PROJECT NO. 57236

PROJECT TO DEVELOP THE TEXAS	§	PUBLIC UTILITY
BACKUP POWER PACKAGE PROGRAM	§	COMMISSION
	§	OF TEXAS

COMMENTS OF GENERAC POWER SYSTEMS, INC ON TEXAS BACKUP POWER PACKAGE PROGRAM VIRTUAL WORKSHOP AGENDA AND RESPONSES TO COMMISSION QUESTIONS

GNRC TBPP Option B: Generac Proposed Adjustments for Improved Package Cost and Market Fit

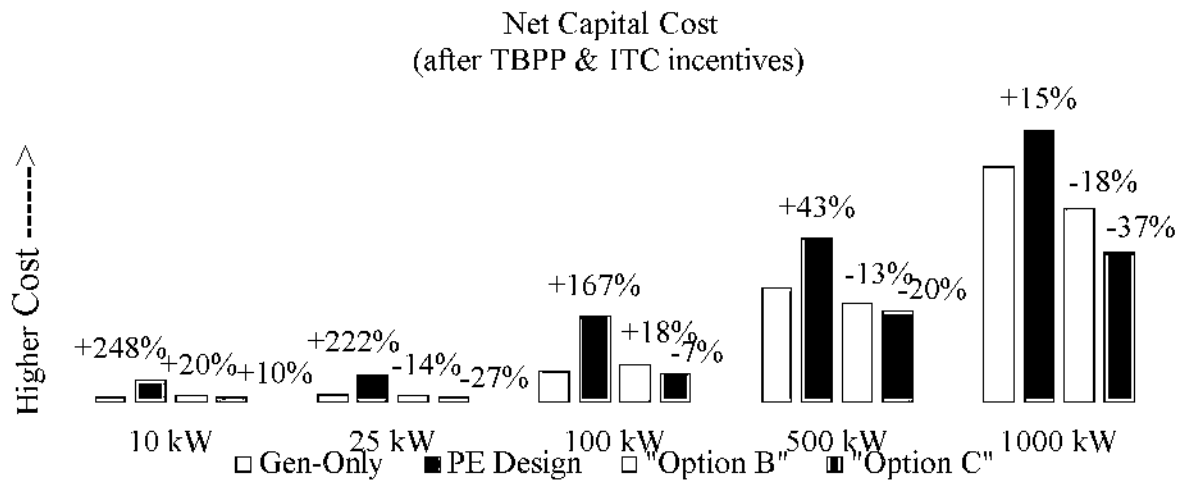
As summarized in the chart below, Generac anticipates that a generator-only solution (in blue) will be a lower cost alternative than any system designed according to the specifications in the Patrick report (in red), even after accounting for the available backup power package incentive and any available Federal Investment Tax Credit (ITC). By contrast, the “Option B” (in green) provides a package conforming specification which, in many cases, is competitive with or is more financially attractive than a generator-only purchase.

Percentages in the chart are in comparison to “Gen-Only” cost. The guidelines of the legislation will be met under the “Option B” proposal at reduced cost which is competitive or in some cases more competitive (after incentives) when compared to buying a natural gas engine alone.

Generac also evaluated an “Option C”, below, which reduces the battery and solar further to ¼ of the report’s recommendation. Percentages are in relation to “Gen-Only” cost.

Patrick Engineering’s proposal. This would reduce cost by a material amount while increasing product/market fit and maintains the 3-asset requirements of the program. The PUCT could maintain the designs proposed by Patrick Engineering for customers that require high resiliency and add additional variants of those designs for customers who do not value near-immediate transfer. In Appendix A we have included a revised SLD and sequence of operation for such an alternative, which for example purposes we have labeled as “Option B”.

GNRC Option B SLD (1000kW Package Example):

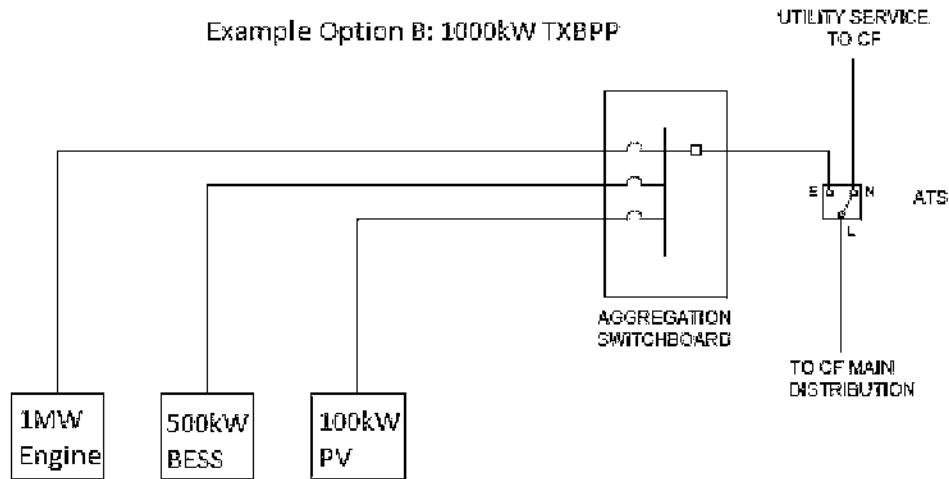
- a. Solar kW sizing to be based on allowing BESS recharge during a 6 hour daylight period. This equates to the solar size being 16% of the BESS rating. See revised Table 3 below.
- 8. Solar is to be designed for fixed tilt ground mount utilizing available existing lot space.
- 9. Systems to be plug and play. This assumes components containers are within close proximity to one another where premade cables can be placed in ground mounted wireways and the containers plugged into one another.

GNRC Comment: In the revised design recommendation, "immediate" does not need to mean "instant". Generator can provide full site backup and revised BESS can supplement.

1. Upon grid failure there is minimal delay to transfer to backup power bus.
 - a. Genset to pick up Critical Facility load within 10 seconds.
 - b. BESS and Solar brought online to load share with generator

2. Genset and BESS to share load.
 - a. BESS kW rating to be 50% of anticipated CF kW rating with production capacity sizing at 1 hour (shown in Table 5 below):

- i. 10kW TBPP - BESS = 5kW/5kWh
 - ii. 25kW TBPP - BESS = 12.5kW/12.5kWh
 - iii. 100kW TBPP - BESS = 50kW/50kWh
 - iv. 500kW TBPP - BESS = 250kW/250kWh
 - v. 1000kW TBPP - BESS = 500kW/500kWh

GNRC Option B SLID (1000kW Package Example):

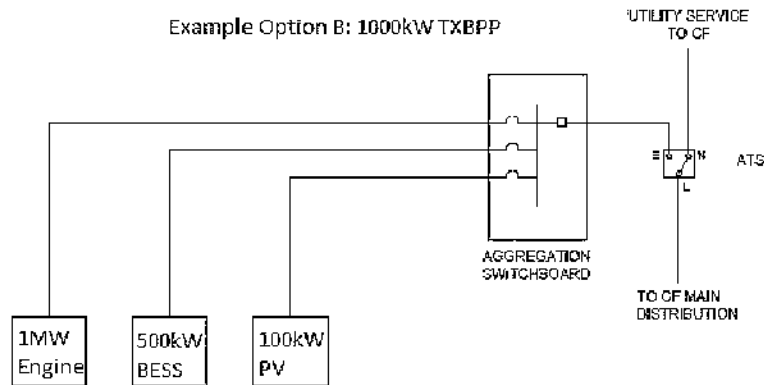
8. Connect to CF main electric service through use of Automatic Transfer Switch (ATS).
 - ~~a. This provides for rapid transfer of power to BESS/TBPP at time of grid failure.~~

- ~~b. a. This transfer could be delayed to prevent rapid cycling in the event of short interval intermittent grid failures. within 10 seconds.~~
9. Minimum five AC kW output range capacities:

1. Upon grid failure there is ~~to be no~~ minimal delay to transfer to backup power bus.
 - a. ~~BESS/Genset~~ to pick up Critical Facility load ~~immediately~~.

- ~~b. a. Genset to start after within 10 second delay~~ seconds.
 - b. BESS and Solar brought online to load share with generator
2. Genset and BESS to share load.

- a. BESS kW rating to be ~~100~~50% of anticipated CF kW rating with production capacity sizing at 1 hour (shown in Table 5 below):
 - i. 10kW TBPP - BESS = ~~10kW/10kWh~~5kW/5kWh

- a. Operates islanded through operation of ATS.
 - i. Generator picks up CF load in its entirety with minimal power interruption (10 seconds) to CF power services.
 - ii. ATS transfer time is set to zero second delay.

- b. BESS and genset share CF load based on control programming.
